DRAINAGE REPORT
FOR
JEFFERSON COMMONS BUSINESS PARK

Re: Jefferson Commons Drainage Report - City Review Comments, Letter of January 3, 1990 (F-17/D61)

RE: DRAINAGE REPORT FOR JEFFERSON COMMONS, RECEIVED NOVEMBER 29, 1989 FOR PRELIMINARY AND FINAL PLAT APPROVAL (F-17/D61)

ATTACHMENT 1

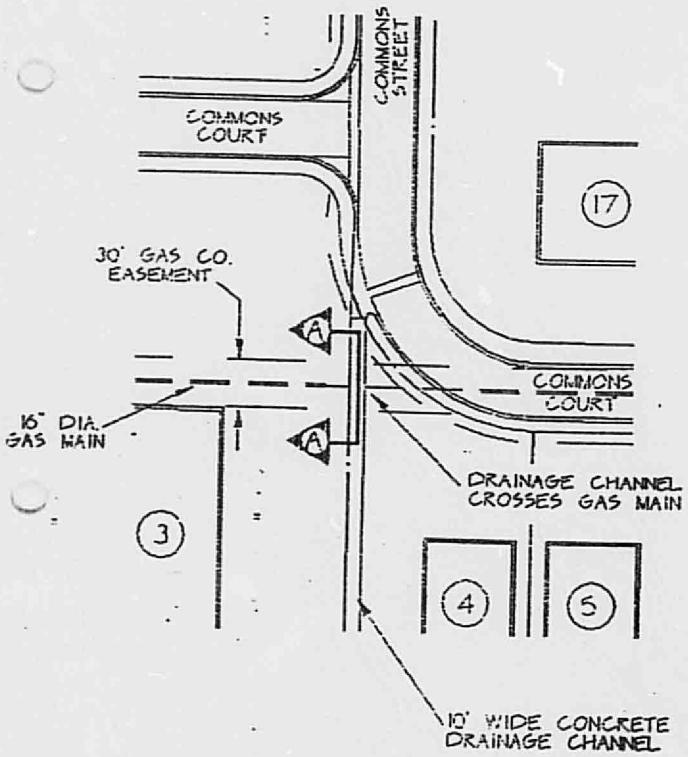
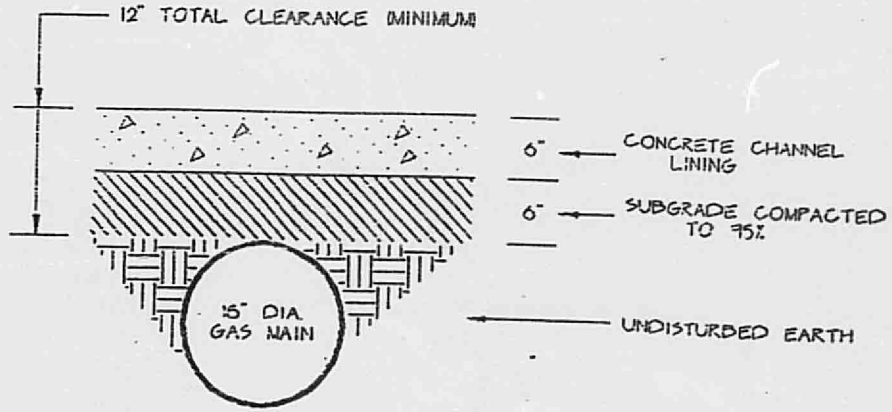
1. We will need encroachment agreements from the Gas Company to build channels in their easements. Please check other utility easements.

Item 1: A Mr. Dennis Depoy (889-2539) with the Gas Company had been contacted in order to coordinate the design requirements for the channel crossing. The crossing criteria as shown in Attachment #1 has been approved by the Gas Company.

ATTACHMENT 4

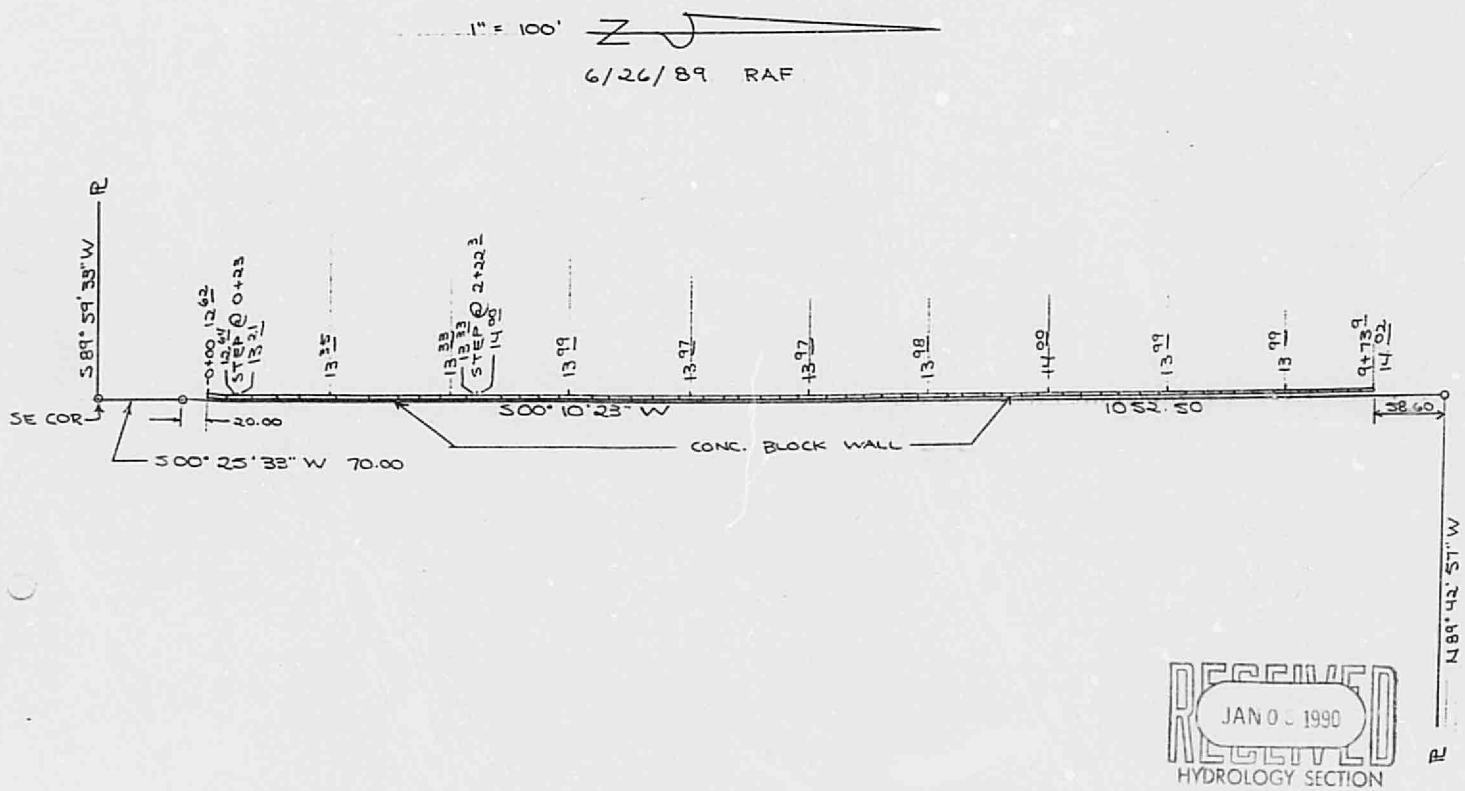
3. We will need written permission and an easement from Albuquerque "6" Drive-In owners to divert flows on their property. Please provide a cross section and hydraulic calculation for the proposed diversion.

Item 3: Attachment #3 shows a grading plan design revision for the Drive-In Theater as completed in 1985. The interception of the flows and subsequent on-site routing of these flows to the south was established with that plan. The construction of a concrete block wall along the adjoining property with Jefferson Commons was as a prerequisite by AMAFCA for Jefferson Common's development. AMAFCA wanted to insure that any future development of the drive-in theater property would maintain the existing flow patterns directly to the Vineyard Arroyo. (See Attachment #4 for the as-built survey of the wall).

ATTACHMENT 5

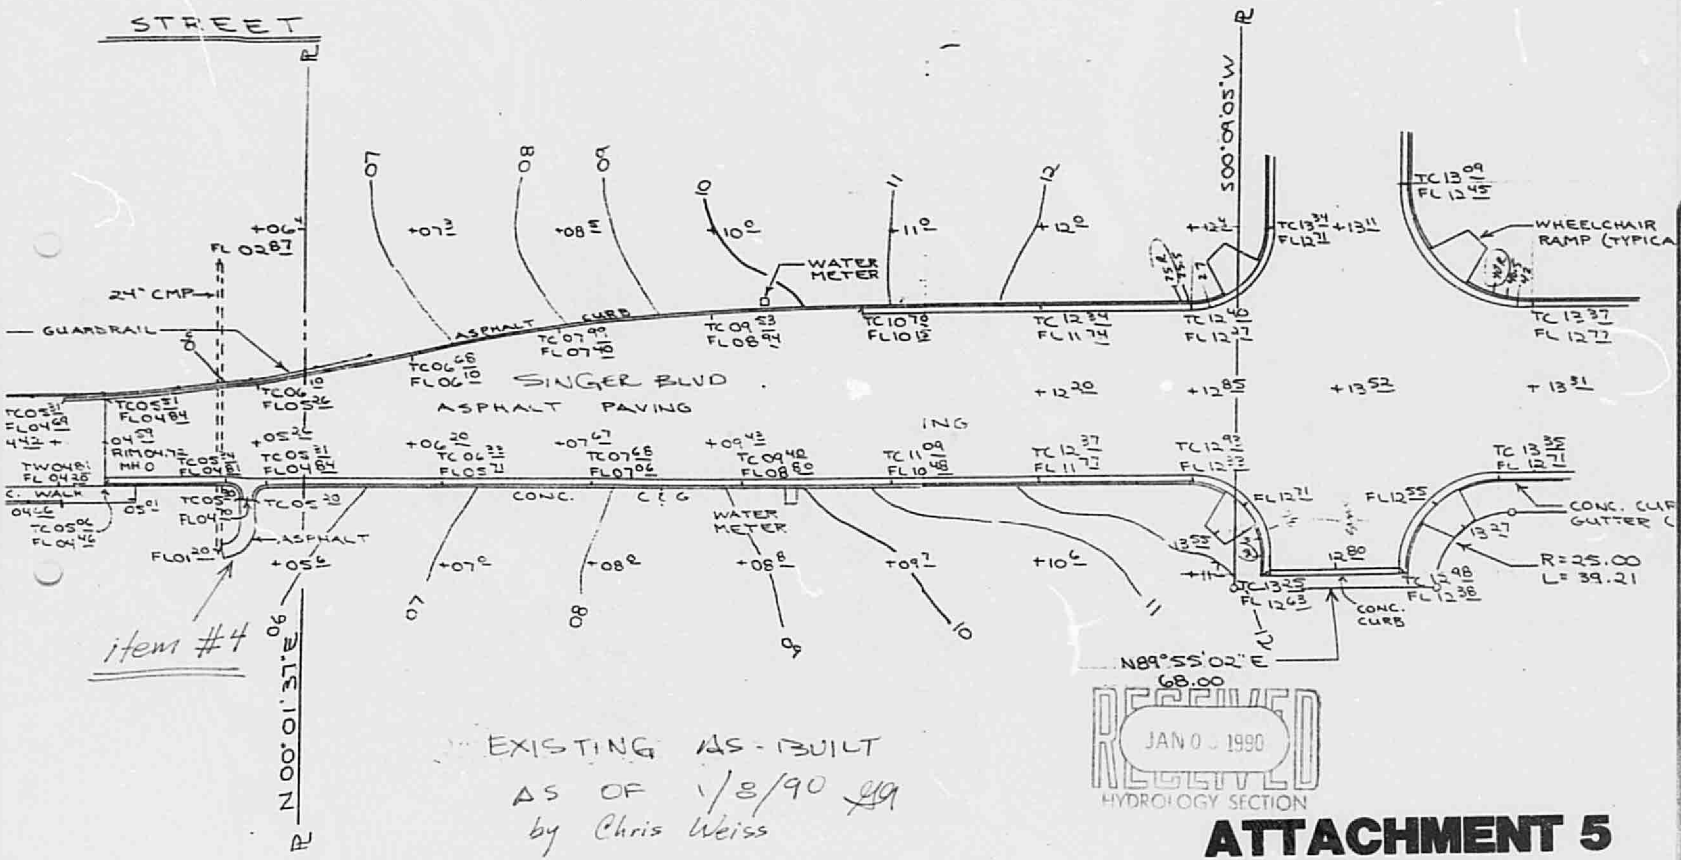
4. Your plan is unclear if Singer Boulevard is existing or proposed to be extended from Midway Park Place to the Diversion Channel. The master plan identifies 3.4 cfs draining through Midway Park Place, you are now proposing a water block. Please address how these flows and flows from Singer Boulevard are to be diverted into the North Diversion Channel. Show street profiles and hydrological calculation for sizing the inlets.

Item 4: Singer Blvd. was under construction at the time of the drainage study for Jefferson Commons, and it was evident that a positive grade from the intersection of Singer and Midway Park had been established to the AMAFCA channel. In light of this direct route to the AMAFCA channel, it was unrealistic to try and turn flows from Singer Blvd. into the Jefferson Commons site, as originally proposed by the Midway Park Master Drainage Plan. Depth of flow in Singer for the 10 cfs developed rate = 0.32: (48' street, s = 2.6%, vel = 3.5'/sec - Plate 22.3 D-3). The flows from Singer Blvd. now enter the AMAFCA side ditch via a 5' wide asphalt rundown located 50' east of the bridge. Capacity of 5' wide rundown at 14%, n = 0.017, D = 0.5', Q = 45 cfs. (See Attachment #5).

ATTACHMENT 6

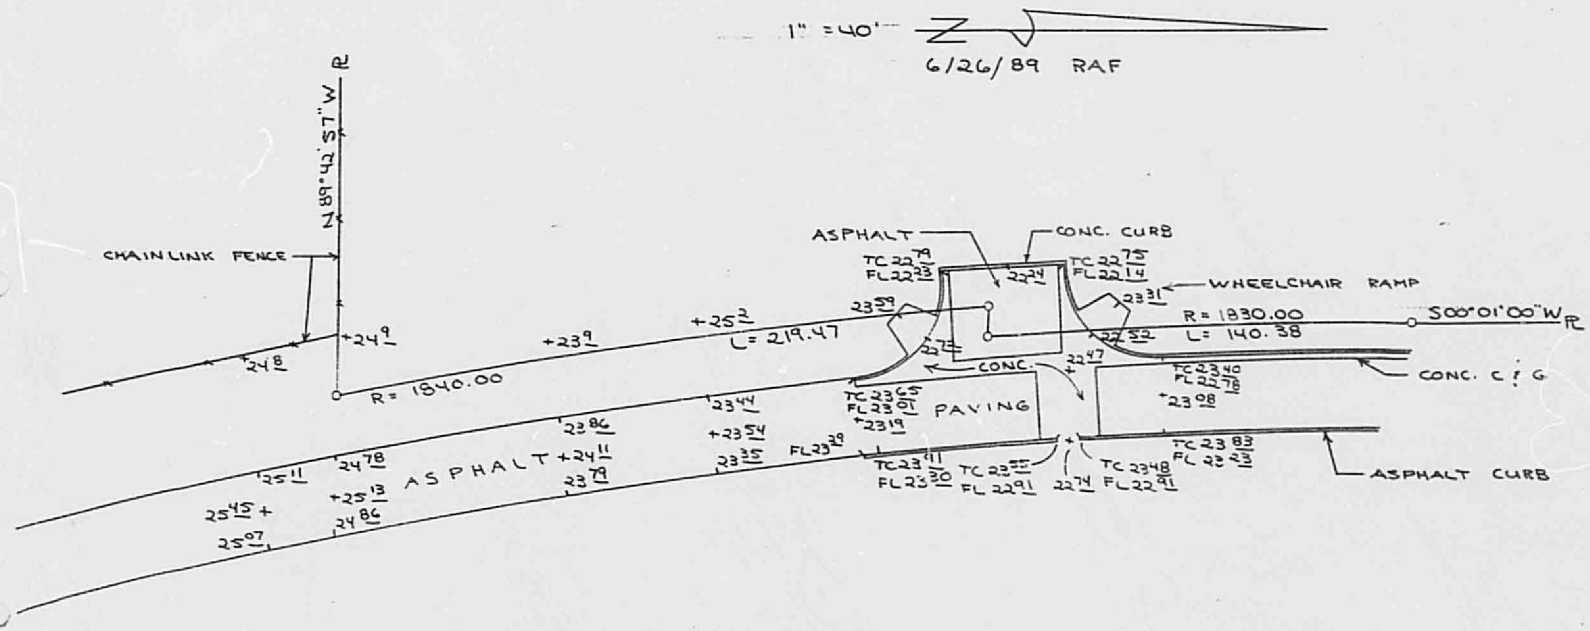
5. Provide a profile or additional details on how your proposing to shift the existing low point at Office Boulevard.

Item 5: Attachment #6 is the as-built survey of the Office Blvd. low point. Attachment #7 is Sheet #7 of the construction plan for this intersection.

ATTACHMENT 8

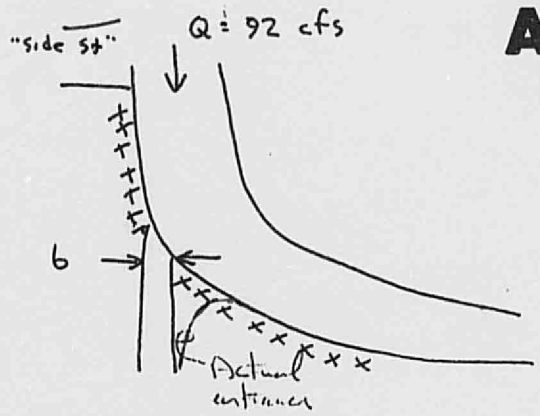
6. Provide the calculations for sizing the curb opening of the proposed channels, the maximum street depth per the D.P.M. criteria is 0.87 feet above flowline for a 100 year storm. A variance from traffic engineering and a maintenance covenant agreement will be required to exceed a depth of 0.87 feet.

Item 6: Calculations for the proposed channels are enclosed as Attachment #8. The depth of flow may exceed 0.87' at the north channel entrance, but the flows will be contained within the ROW by diversion berms located at each side of the channel entrance. (See Attachment #9). The south channel entrance did not have any problems accepting the street runoff and is in fact larger than needed to handle the flows, but was sized primary for maintenance requirements. (See Attachment #2 - Table of Channel, Street Flow Depths and Velocities, and Freeboard).

change b to 20 ft

The curb is 4.51 ft. Thus a berm (or lot elevation) is needed where I indicated XXXX
